## 1170 REPUBLICAN STREET

MUP Recommendation: DPD #: 3024575  
2018.03.14

1170 REPUBLICAN STREET / MUP RECOMMENDATION MEETING

## BUILDING OVERHANG SETBACK AT PROPERTY CORNER

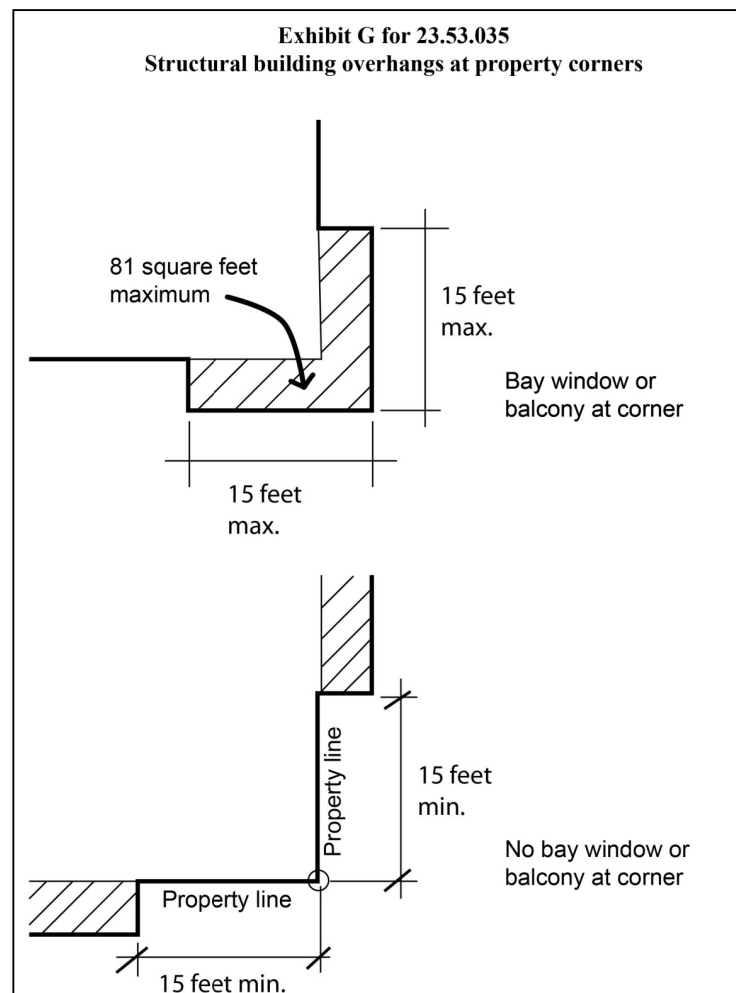
Corners: Bay windows, balconies, and other projections may be located at a property corner but are limited to a maximum width of 15 feet along each facade of the corner, and a maximum total horizontal area of 81 square feet per floor. If there is no bay at the corner, then the minimum distance from the property corner to the nearest projecting bay is 15 feet (see Exhibit G for 23.53.035).

To maintain the intended pattern of the facade miradors and coordinate with the interior wall layouts, we are requesting a reduction in the corner dimension from 15'-0" down to 13'-8" on one side and 9'-5" on the other.

## BUILDING ENTRIES AT STREET FRONT

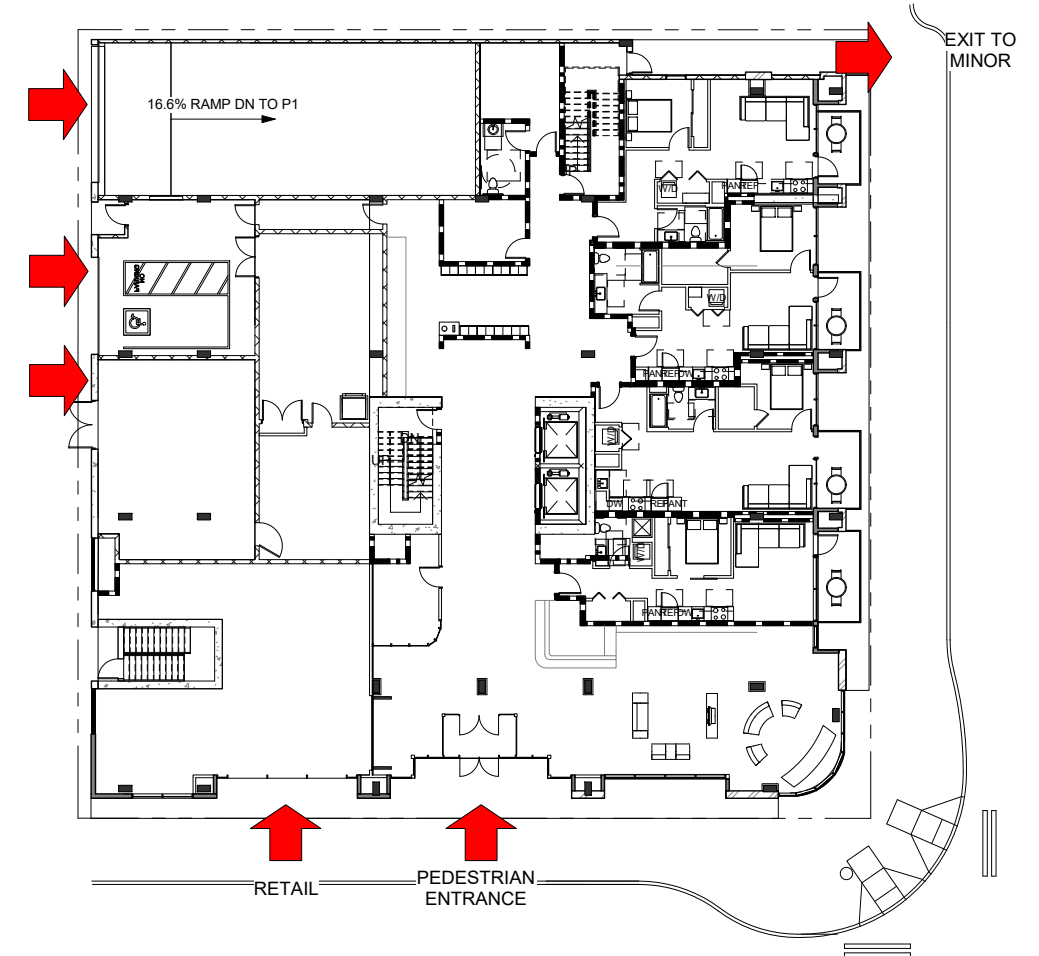
Primary pedestrian entrance. In the SM-SLU, SM-NR, and SM-UP zones, each new structure facing a Class 1 Pedestrian Street is required to provide a primary building entrance for pedestrians from the street or a street-oriented courtyard that is no more than 3 feet above or below the sidewalk grade.

It was noted in the preapplication meeting minutes that an entrance along Minor would be required. The above code section does not seem applicable to Minor as it references a class one pedestrian street. Regardless, we are making this departure request to make sure it has been addressed as needed.

Given the scale of the project and the proposed ground floor uses, we feel that only one pedestrian entrance is necessary. We have provided the entire length of republican and the portion that turns the corner to Minor as having a strong connection with the street.

For the units along Minor, we feel its in the best interest of the city to have those patios populated more often than not. To accomplish this we think its best to provide some mild separation in order to privatize the space. There are doors to access this area from the interior but they are not designed to be entered from the street. Based upon our observations of other configurations in the area we think this could be more successful.
